MAS004040 RU 24-07

Rapid Update 705 MC20 Cielo – Gearbox Oil Leak Check

DATE: MARCH 7, 2024

Example of oil leak around the oil filter cover

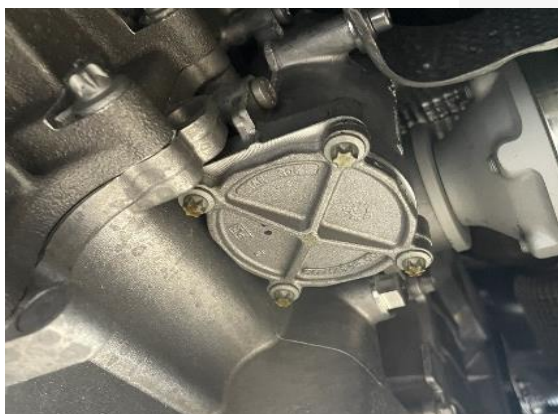
1. Due to a potential oil leak around the oil filter cover, it is necessary to replace it following the Instructions outlined in the workshop manual.

IMPORTANT: For this action it is necessary to use only new components that have a recognition mark as shown in the following image. The use of unmarked components does not guarantee the success of the operation.

Example of oil leak around the differential area

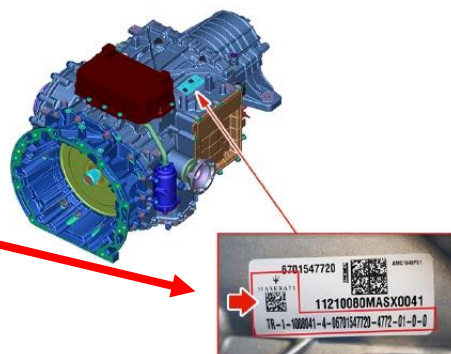
1. Due to a potential oil leak around the differential area of the gearbox, it is necessary to replace the entire gearbox assembly following the instructions outlined in the workshop manual.

IMPORTANT! READ THE WORKSHOP MANUAL COMPLETELY BEFORE PROCEEDING WITH THE REPLACEMENT.
SECTION 03.10 – 1 (Procedure N. 03.10.060 15 COMPLETE AUTOMATIC GEARBOX – Replacement)
